DRAINAGE PLAN
 PRELIMINARY PLAT

FARMINGTON SQUARE 2ND ADDITION

A REPLAT OF PART OF LOT 4, BLK. 3, FARMINGTON SQUARE

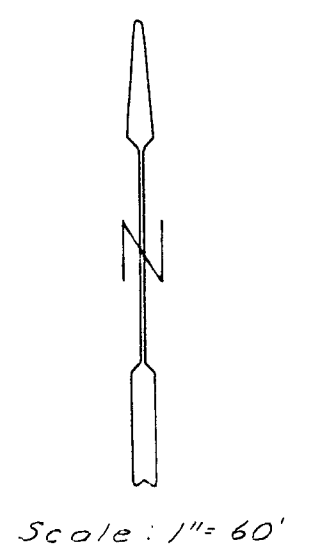
This is inconsistent w/ SWS 116 plan. Contour elevations seem to be in error.

Revised plan w. corrected elevations requested
 11/1/80
